APPENDIX B ARCHITECTURAL DESIGN REPORT

BUILDING J DESIGN REPORT SSD Application

Museums Discovery Centre

APPENDIX D: SDRP RESPONSE

ENTRY SQUARE

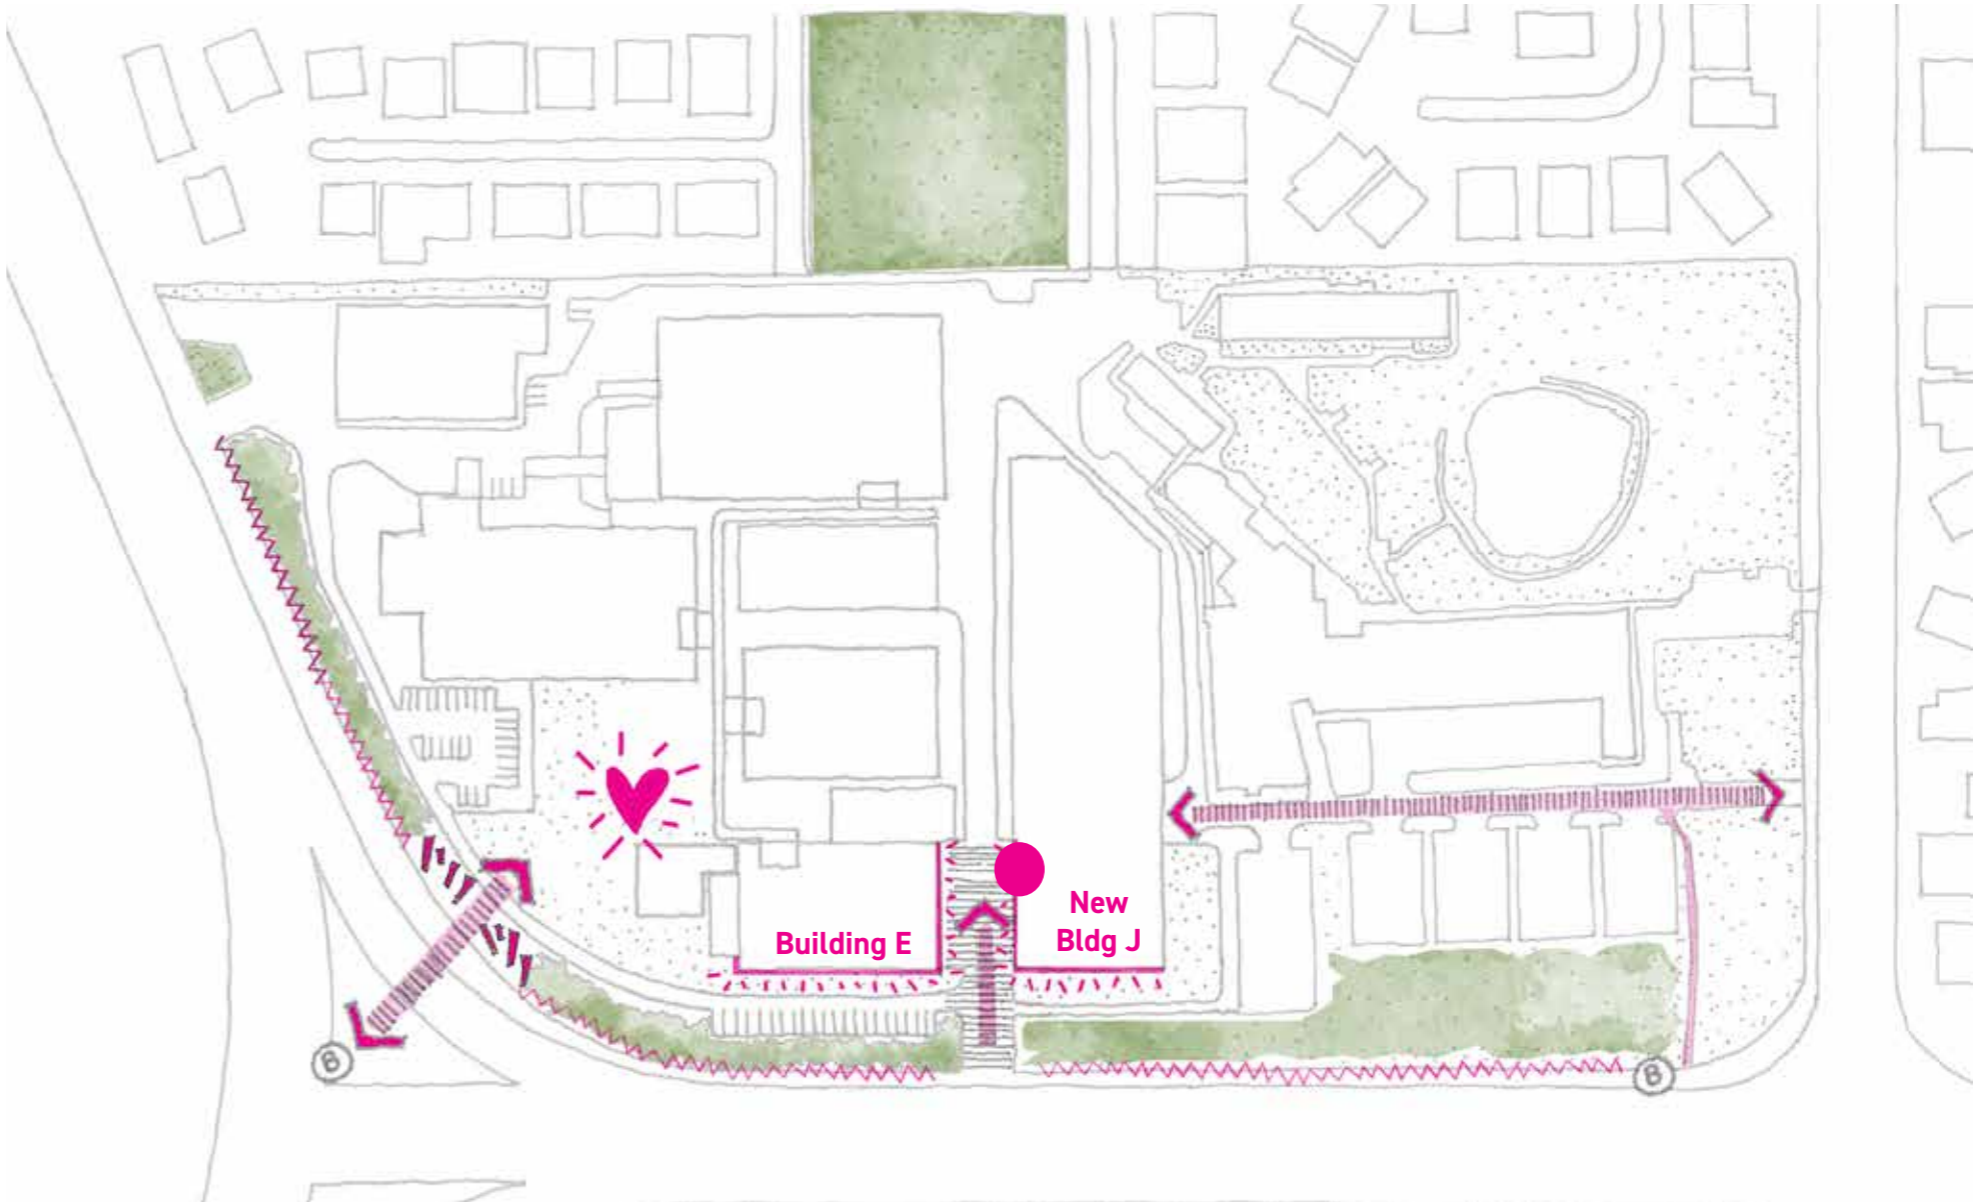
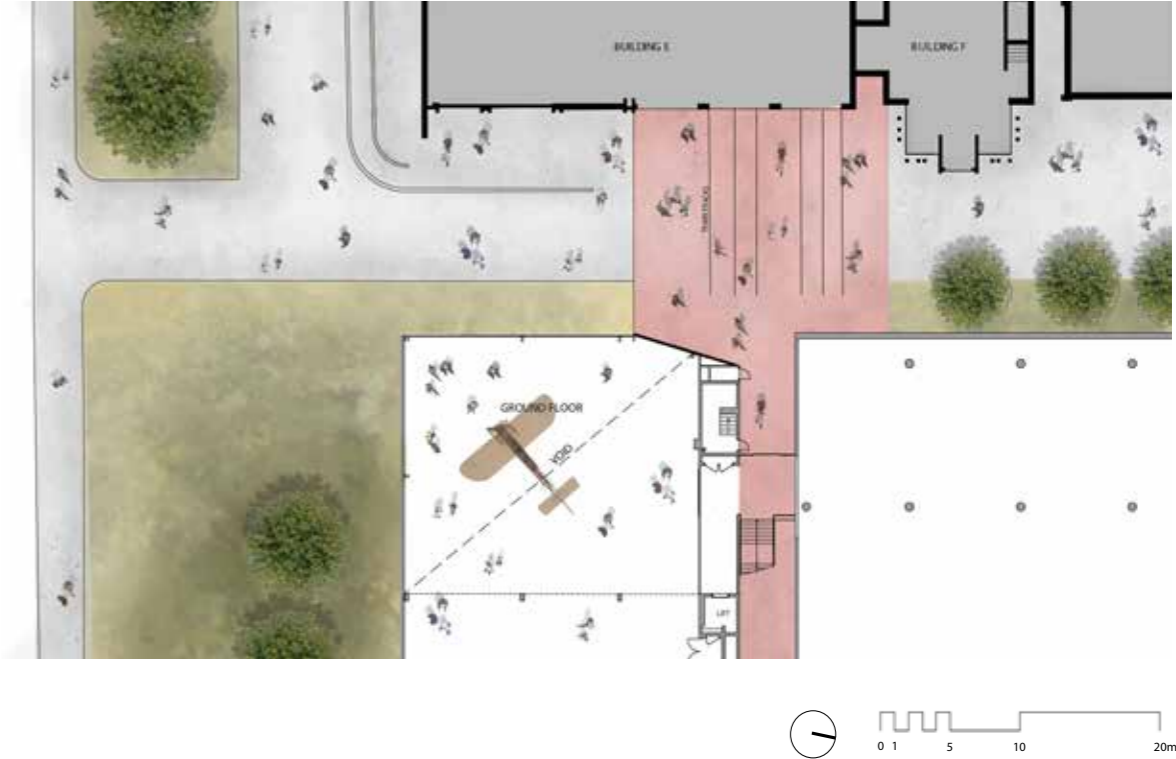
Provide greater detail on the proposed 'entry' square at the intersection of the N/S and E/W axis, to include short term and longer-term plans. Demonstrate that the scale is appropriate.

The diagram on the previous page shows the long term vision for adjacent entries between Building E and the proposed Building J. The design of Building J will catalyse this long term vision by placing a dedicated entry and arrival experience along the North/South spine. The future reorientation of an entry along the North/South spine for Building E will create an arrival 'square' between the two main public buildings within the MDC site. This square will be detailed as part of the Building J works and further developed by MAAS for the North/South spine works that will be undertaken as part of a future works package as and when funding becomes available.

As part of the Building J works, it is proposed that a surface coating will be applied over the existing concrete surface to be consistent in colour with the new entry ground plane treatment for Building J- the intention is to carry this finish through the public East/West link of the new building.

Installations can temporarily occupy the Entry square, reinforcing the link between Buildings J and E, and activating the space.

POCKET PARK

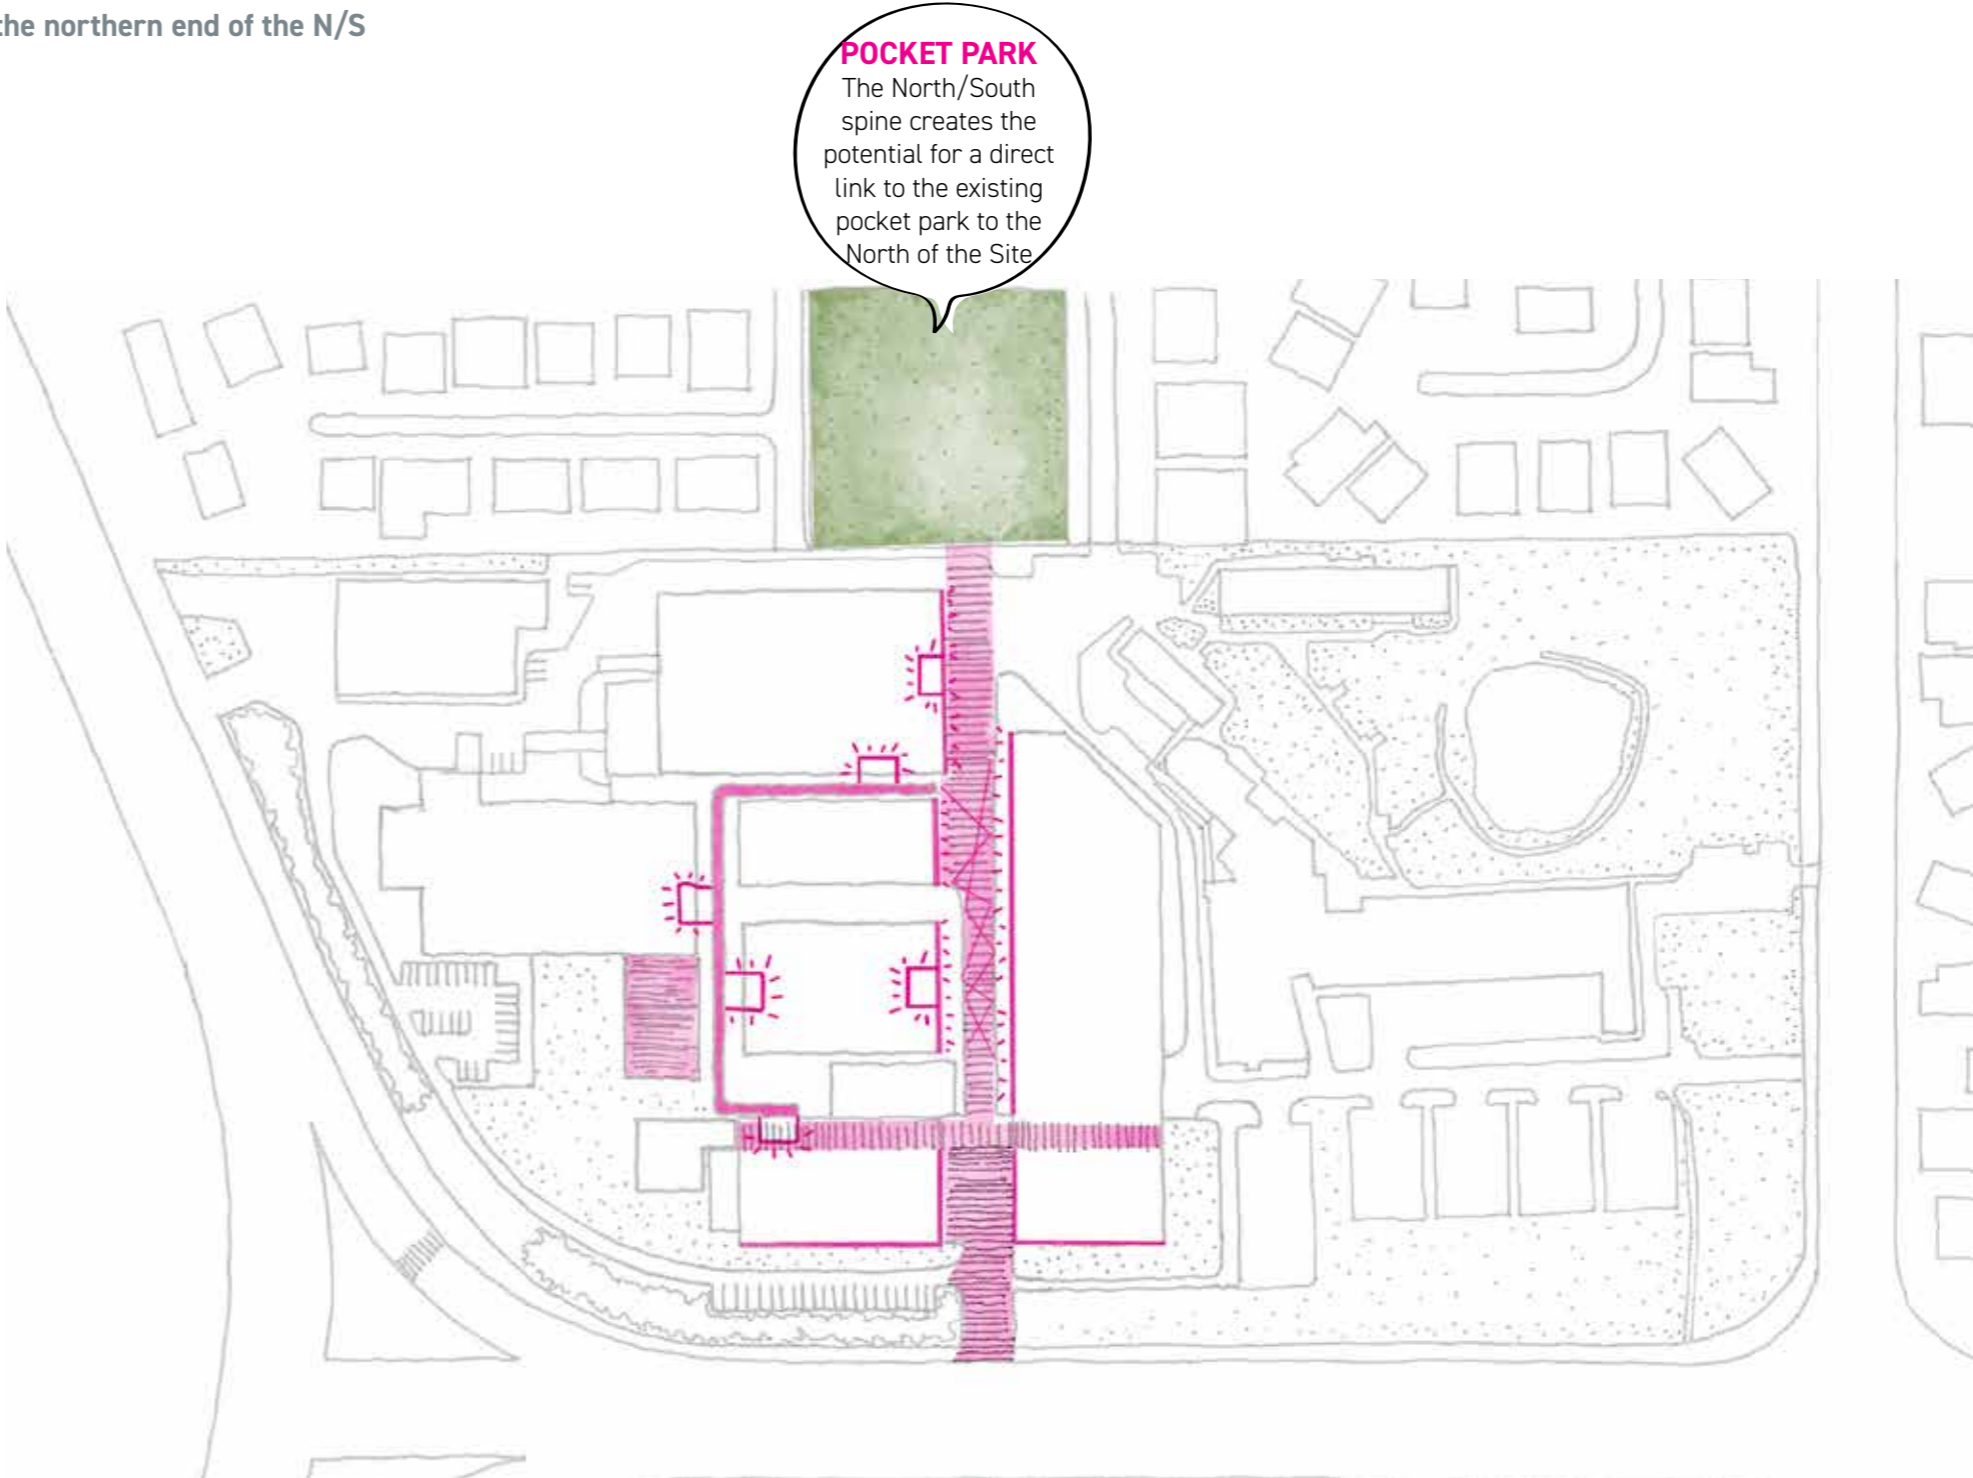
Illustrate the desired future condition for the pocket park/public square at the northern end of the N/S axis and how it will be integrated into the campus.

The long term vision for an enhanced north south spine through the site will provide the opportunity for future connections into the pocket park located to the north of the site between Sunderland Avenue and Castlegate Place. Any enhancement of this park is outside of the scope of this project and the long term master planning of the MDC site.

Future connections to this pocket park would be subject to further community consultation as well as the desires of The Hills Shire Council.

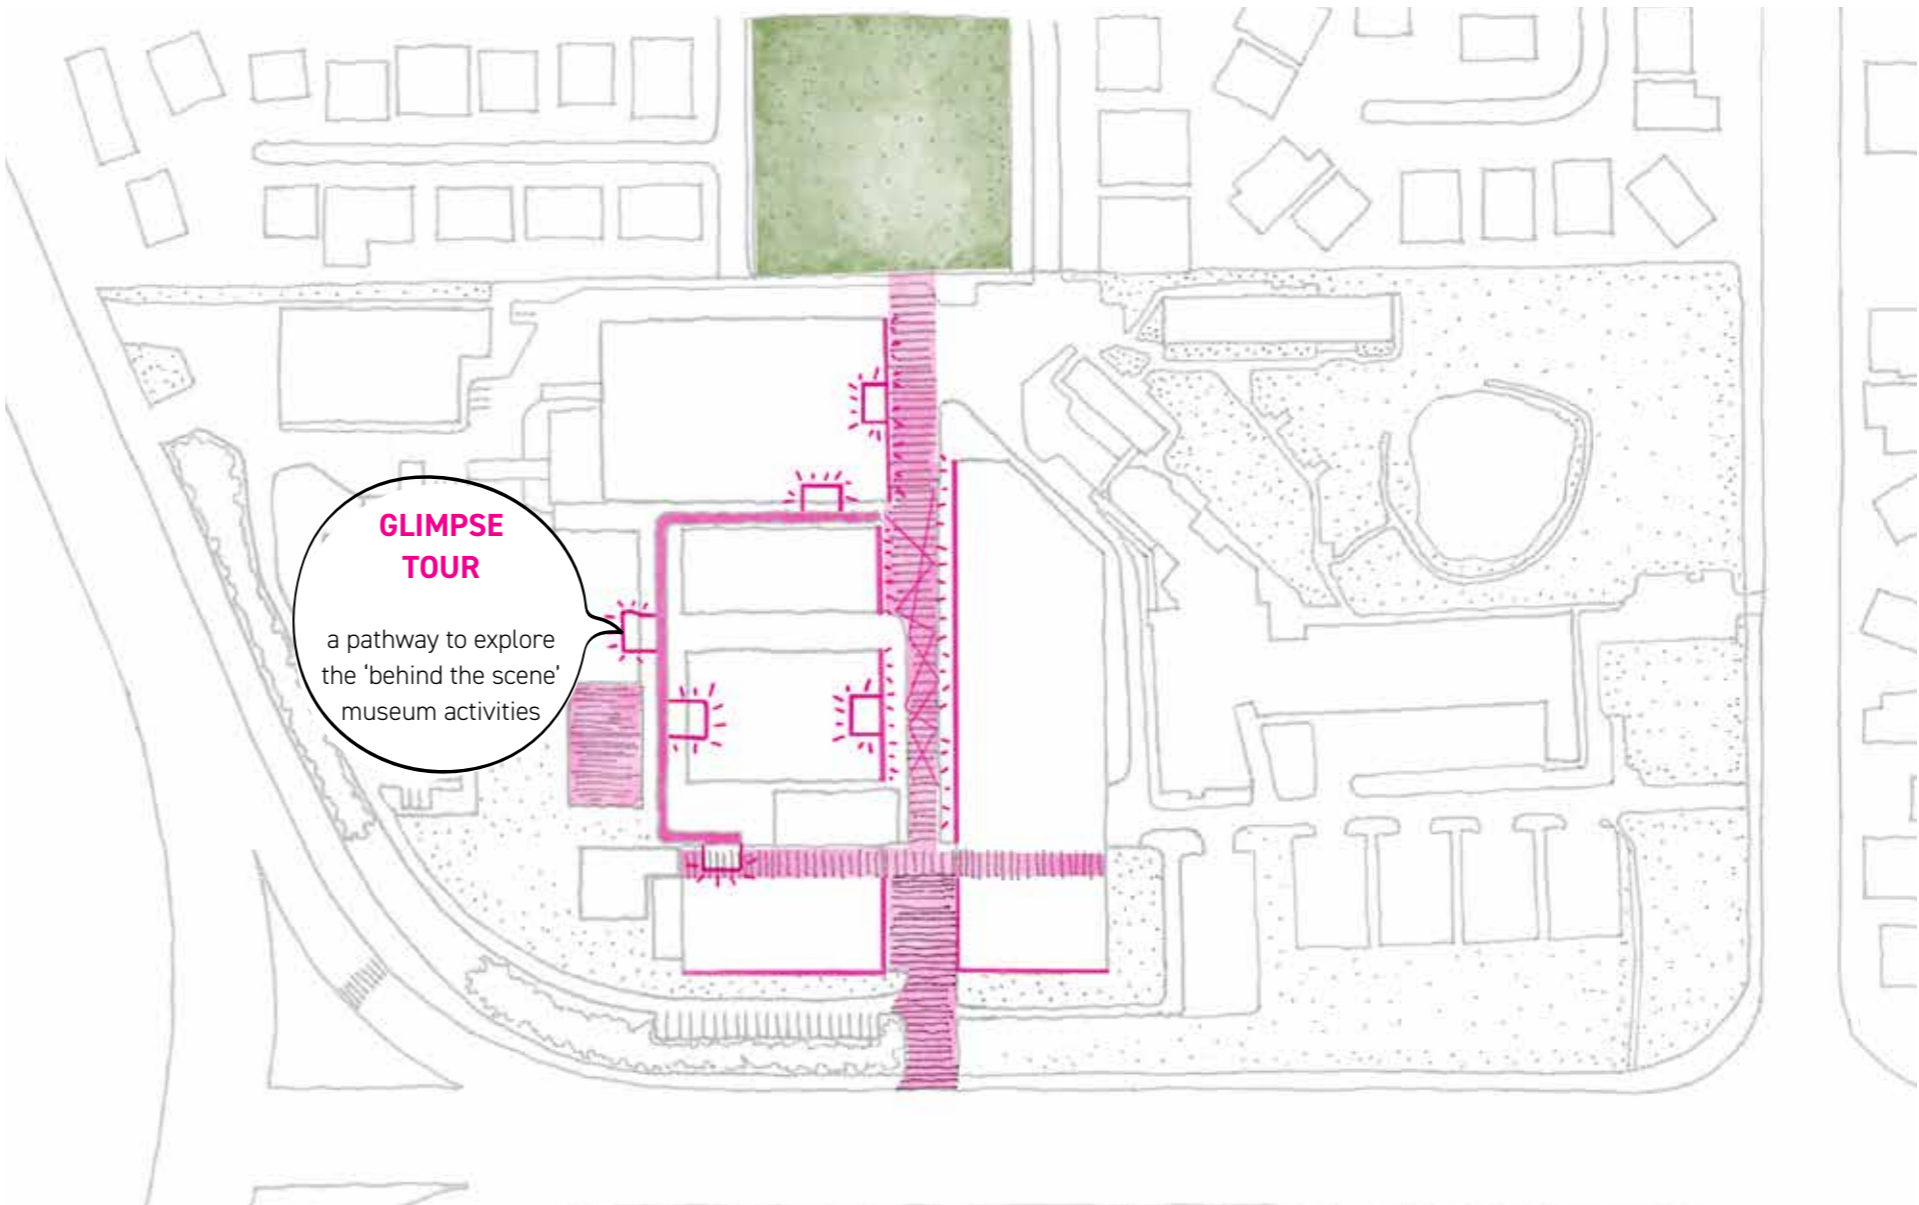
Provide a series of diagrams to illustrate how temporary activation of exterior spaces will operate and can be staged over time.

The diagram shows the long term vision of the Museum for the creation of a North/South spine through the MDC site. The activation (both short term and long term) is outside the scope of the Building J proposal, however the existing north south spine provides a blank canvas from which a range of temporary activations relating to the operations of the MDC can be undertaken.

Future ideas for the North/South spine include redevelopment of entries into existing stores. This would require re-planning of storage within these stores to permit public access.

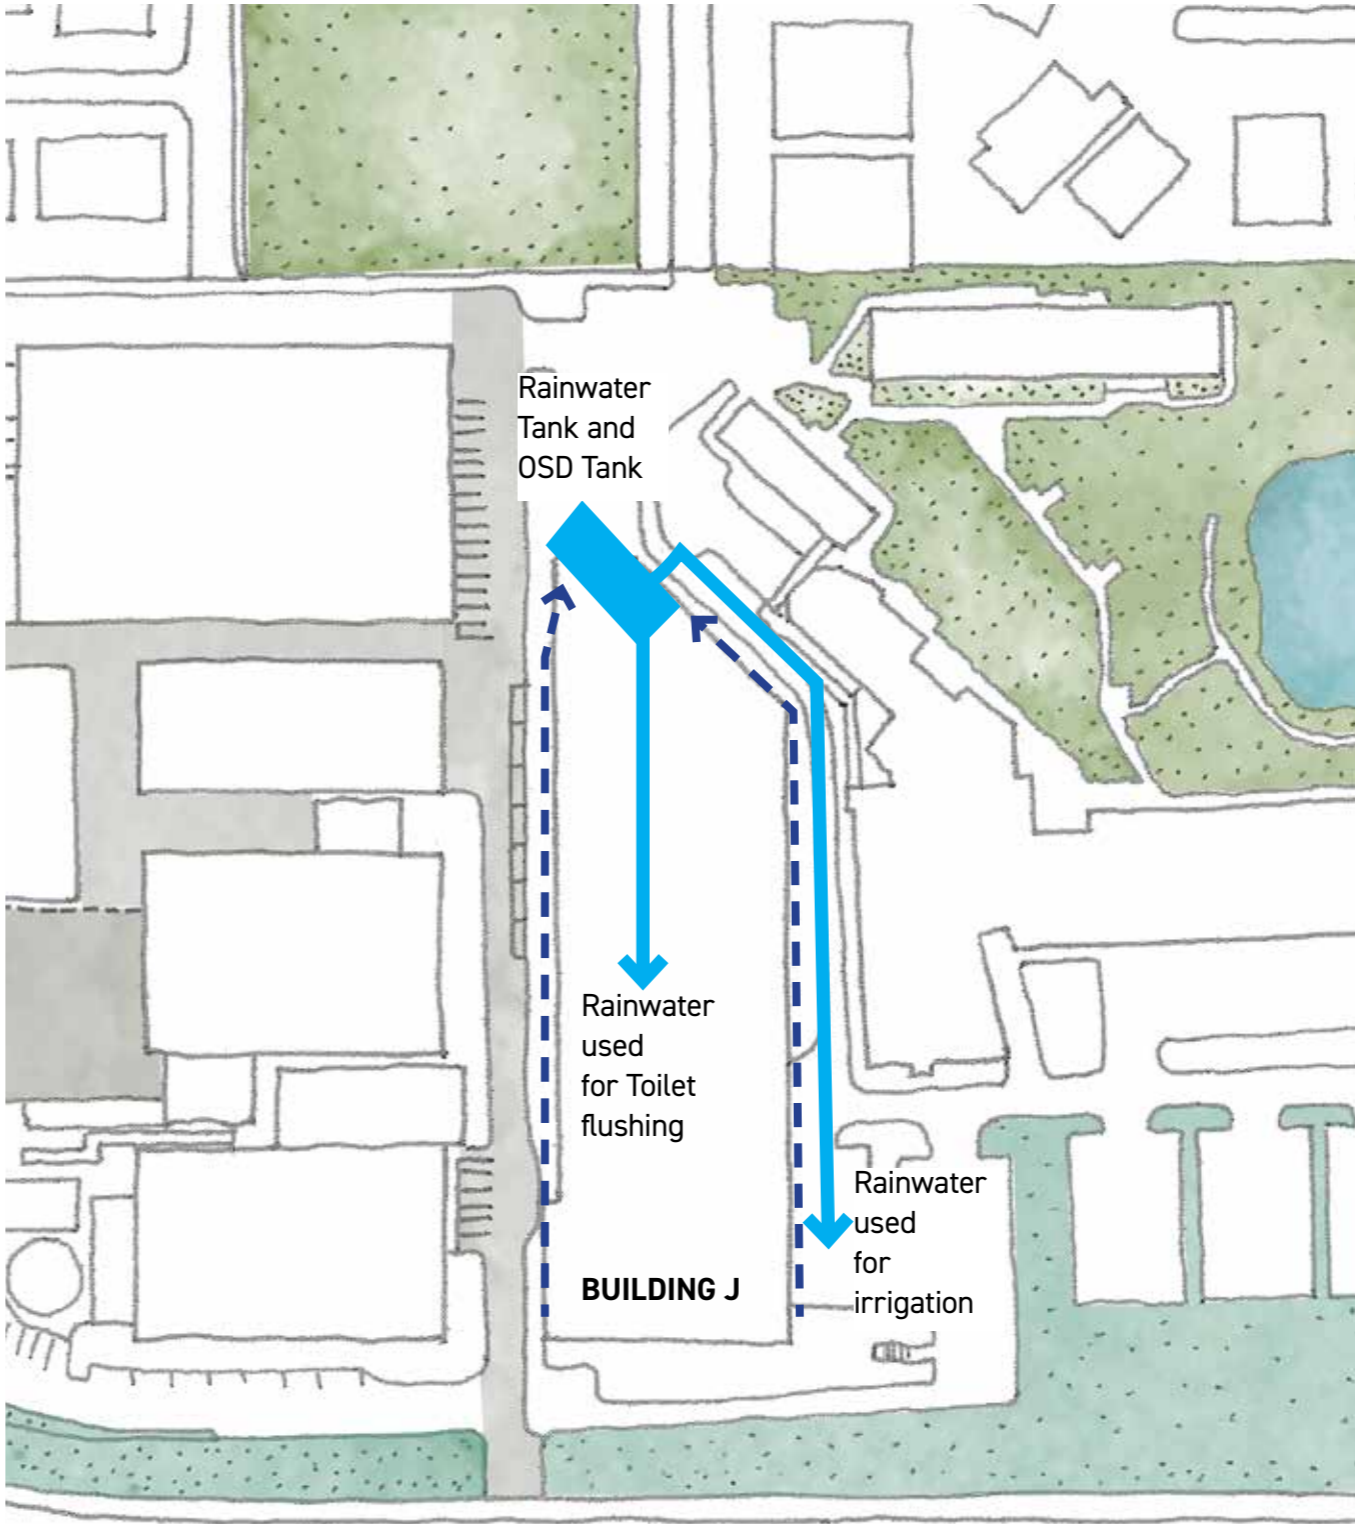
Provide details of total tree canopy to be achieved, noting a 40% canopy target for Greater Sydney in line with Government policy.

Clarify the mechanics of the proposed tree offset program.

The proposal includes the removal of 337 trees from the site, most of which are from a former plantation. A Tree Replacement Strategy is proposed as part of the SSDA that includes a commitment for replacement planting at a 2:1 ratio within the Hills Shire LGA. This replacement planting will result in a net increase of canopy within the LGA as the existing plantation canopy, whilst dense is not reflective of the potential canopy of the planted species.

Through the proposed 2:1 replacement planting, additional canopy cover will be contribute to the NSW Government's policy to increase canopy cover within Greater Sydney to 40%.
